SLATER SUBDIVISION

APPLICATION NUMBER 22 DATE May 19, 2005

REQUEST Subdivision

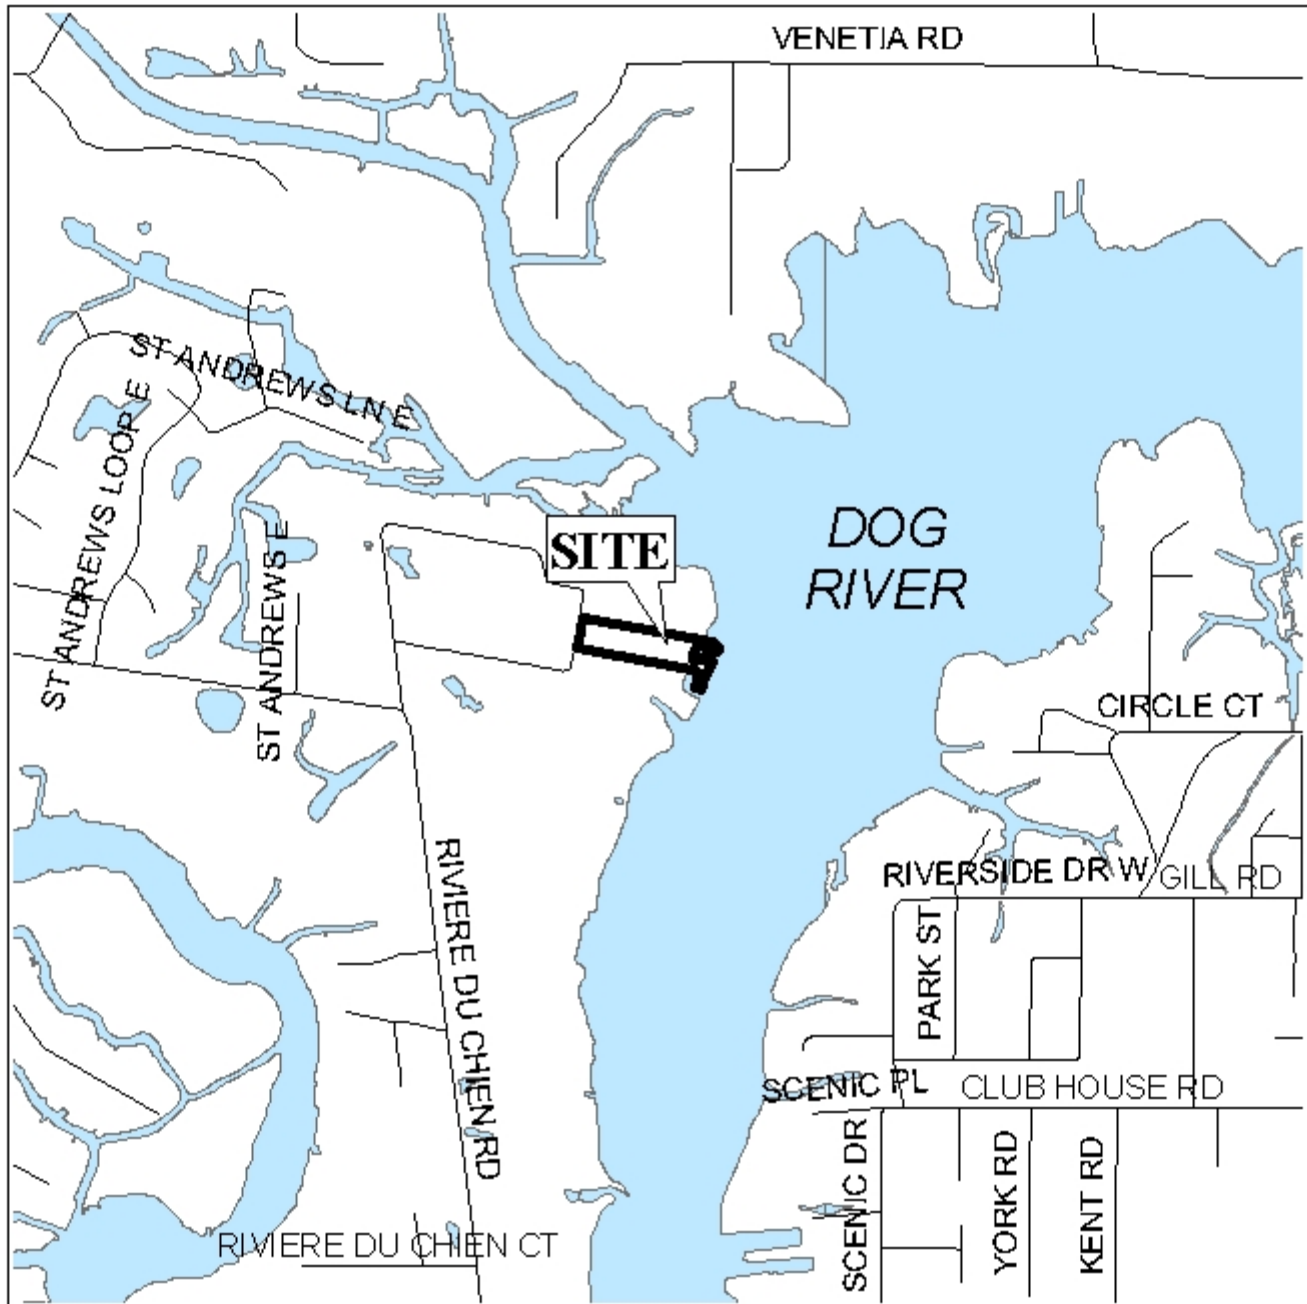
As proposed, Lots 2 and 3 would exceed the maximum width to depth ratio as recommended by the Subdivision Regulations; therefore, a waiver of Section V.D.3., would be required. Narrow, deep lots are typical along waterways, thus a waiver of V.D.3. would be appropriate.

As indicated on the plat, the site is located on Dog River and as such the area may be environmentally sensitive; therefore, the approval of all applicable federal, state and local agencies would be required prior to the issuance of any permits.

As proposed, Lot 2 has only 25-feet on a public road. A note should be placed on the final plat stating that there can be no future resubdivision of the lot until additional frontage is provided on an opened and maintained public right-of-way.

With a waiver of Section V.D.3. (width to depth ratio), the plat will meet the minimum requirements of the Subdivision Regulations and is recommended for Tentative Approval subject to the following conditions: 1) the approval of all applicable federal, state and local agencies prior to the issuance of any permits; and 2)) the placement of a note on the final plat stating that there shall be no resubdivision of Lot 2 until additional frontage is provided on an opened and maintained public right-of-way.
